AMENDMENTS TO THE DRAWINGS:

REMARKS

ANNOTATED SHEET SHOWING CHANGES

Fig. 5

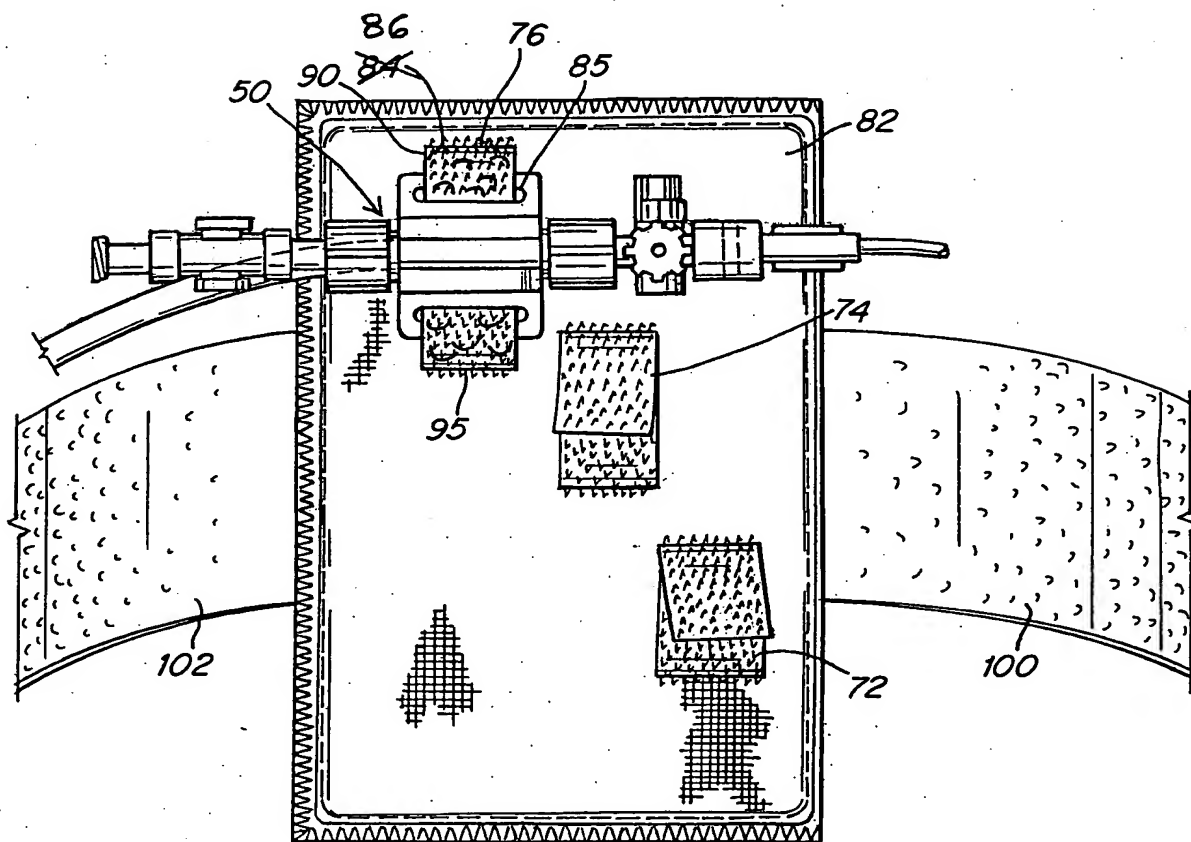
Subject to the approval of the Examiner, Applicants propose correcting FIG. 5 by changing reference numeral 84 to reference numeral 86, and changing the hook surface to a loop surface, as shown on the annotated sheet. Support for this change can be found in paragraph no. [027] of Applicants' specification ("loop surface 86 faces away from base 82"), and in the informal drawings sheets originally filed with the present application which correctly labeled the surface with reference character 86. No new matter has been added.
